EPA Superfund Explanation of Significant Differences

New Hampshire Plating Company Superfund Site Merrimack, NH

September 2020

DECLARATION FOR EXPLANATION OF SIGNIFICANT DIFFERENCES NEW HAMPSHIRE PLATING COMPANY SUPERFUND SITE MERRIMACK, NEW HAMPSHIRE SEPTEMBER 2020

Figure 1 – Site Plan – Shallow Overburden Trichloroethene Data

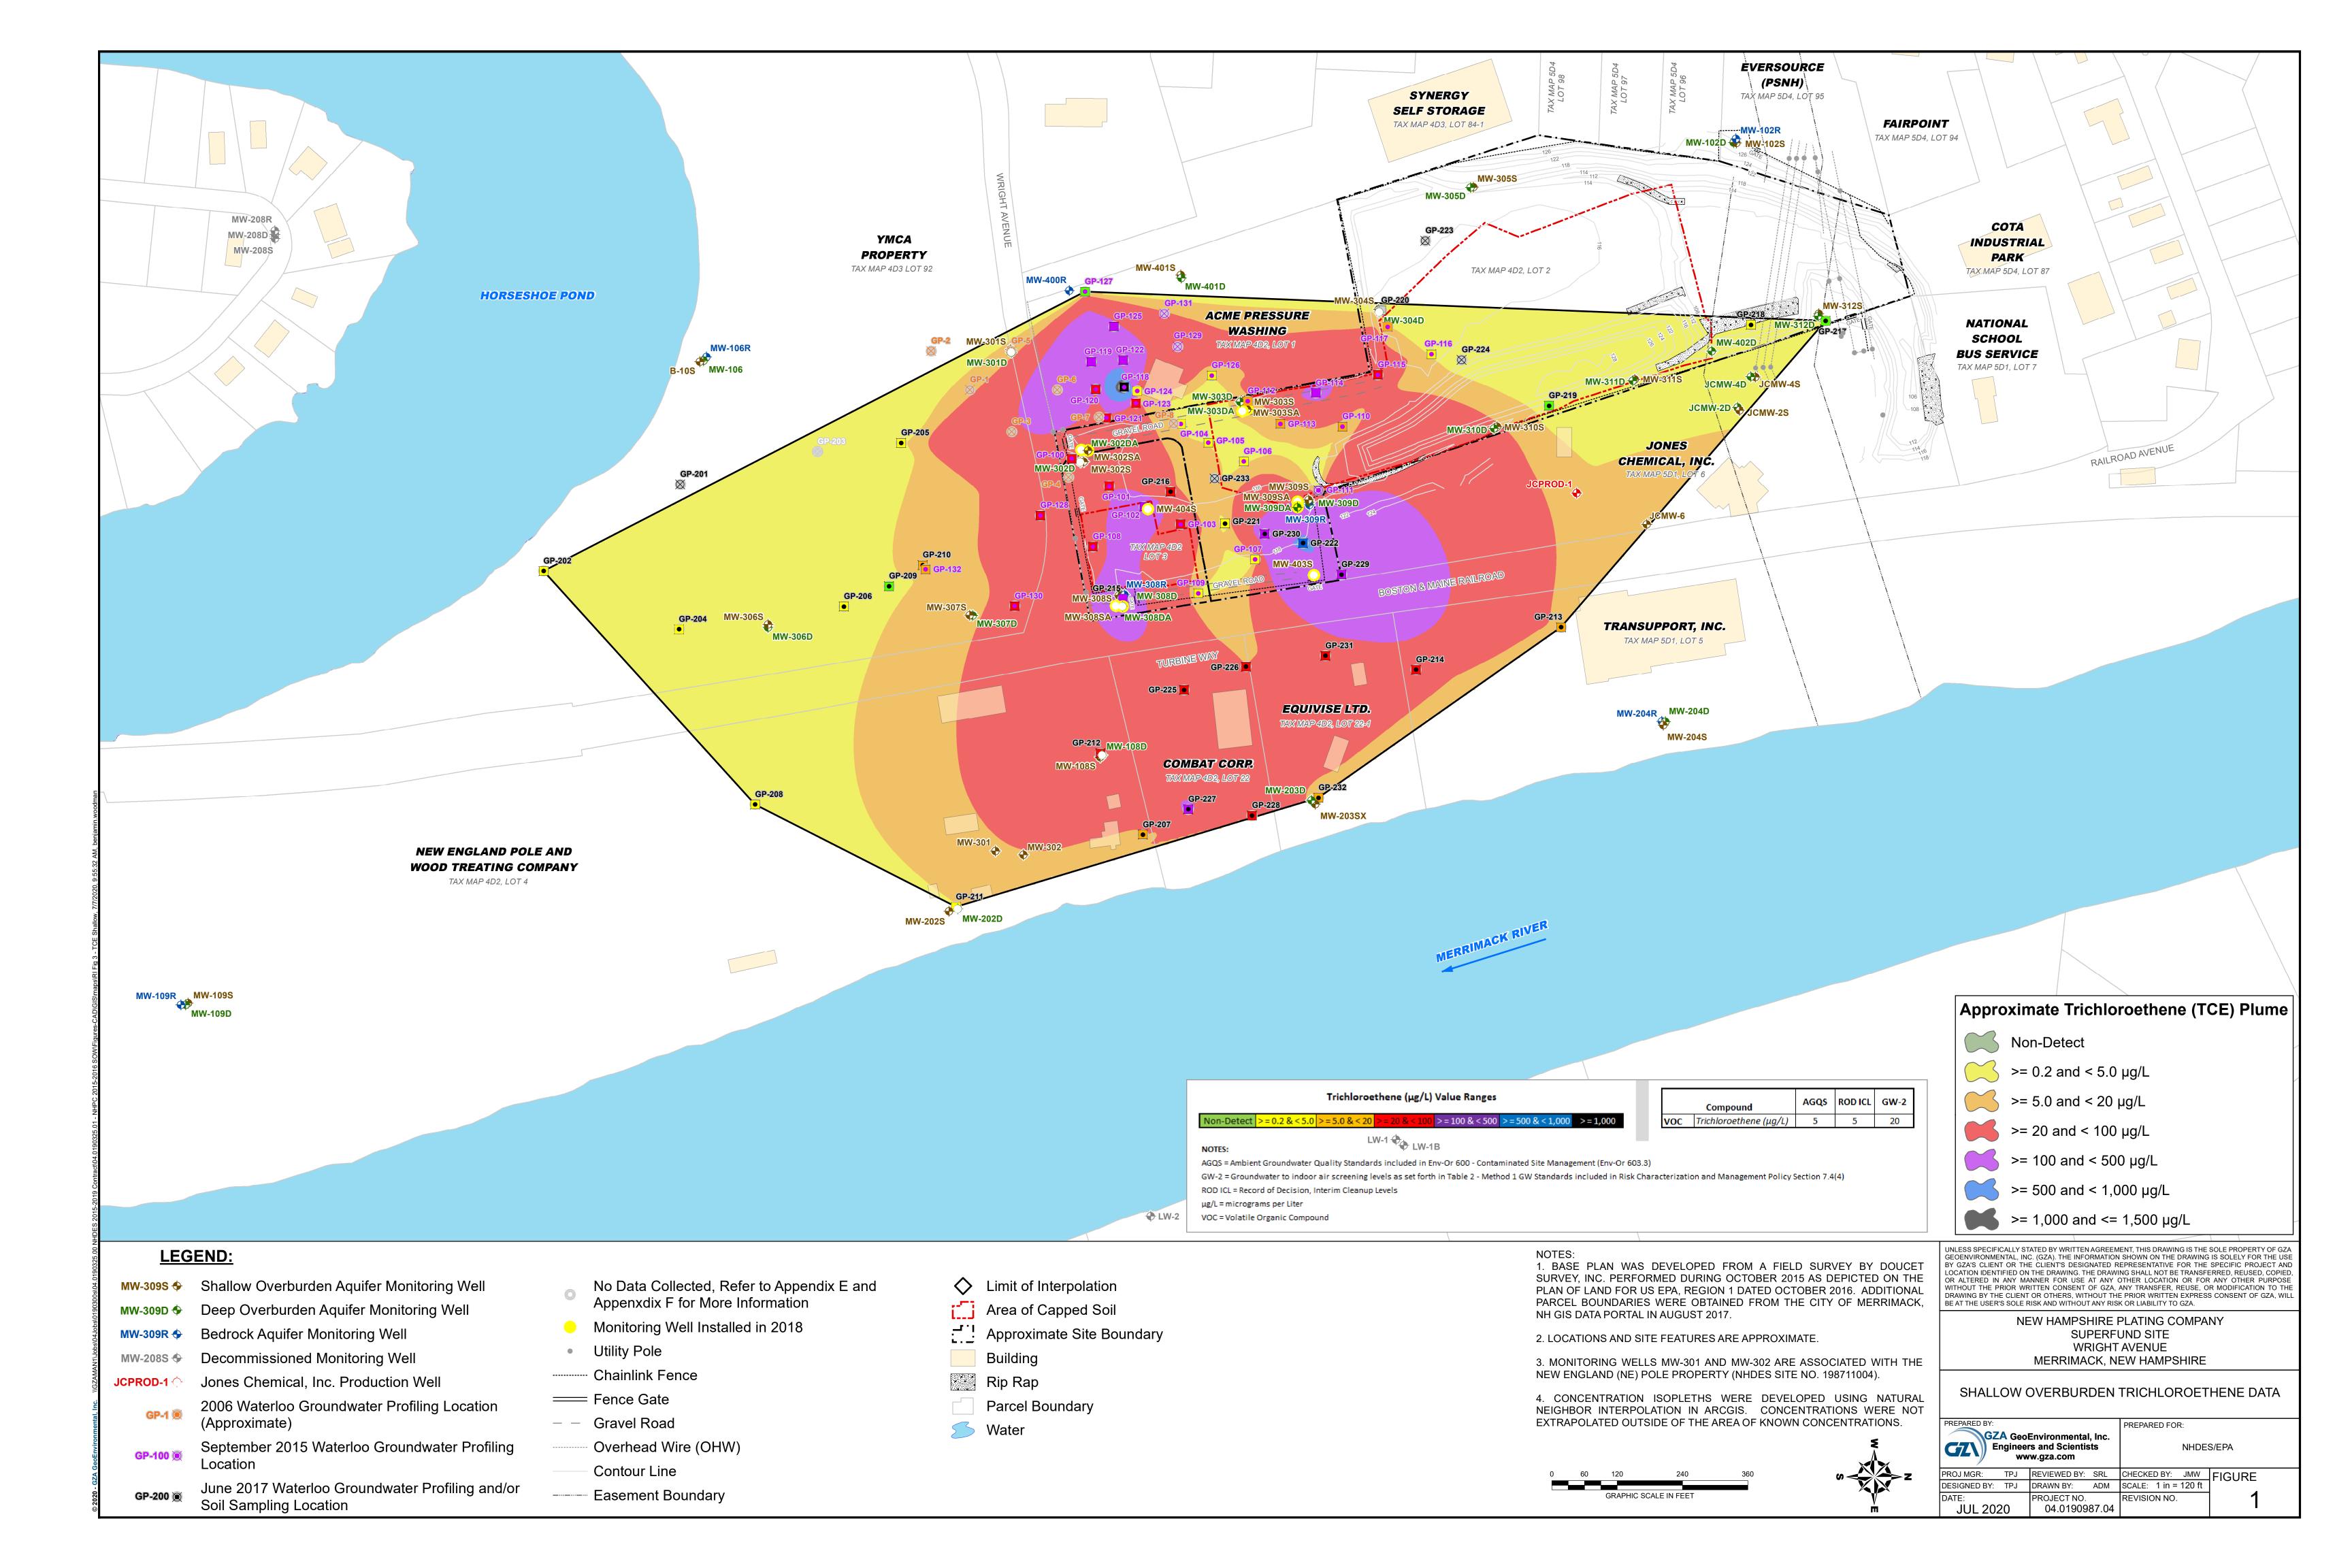
- b. the modification of existing IC requirements under the ROD for the NHPC Properties and other properties within the groundwater cVOC plume (see Figures 1 and 2) with contamination levels that exceed the EPA default VISLs to require assessment of risk from vapor intrusion potential, and incorporation of any necessary measures based on the risk assessment to minimize and/or mitigate risk to human health into any new construction, or existing building renovation, expansion or change in use, as determined necessary by EPA and NHDES.

- c. the modification of existing IC requirements under the ROD for the NHPC Properties and other properties over the groundwater cVOC plume (see Figures 1 and 2) to include a prohibition on the installation of new wells and/or the withdrawal of groundwater without EPA and NHDES permission.
- 3. Applicable or Relevant and Appropriate Requirements (ARARs) and To Be Considered guidance (TBCs) identified in the 1998 ROD, as modified by the 2007 ESD, are updated to incorporate additional promulgated state and federal standards and guidance related to vapor intrusion.

See Figures 1 and 2 for maps of currently known off-Site properties within the groundwater plume with groundwater contaminant levels above the EPA default VISLs, subject immediately to this change. If the contaminant plume changes or additional information becomes known that reveals that additional properties within the groundwater plume have groundwater contaminants levels above the EPA default VISLs, those properties will also be subject to this IC requirement.
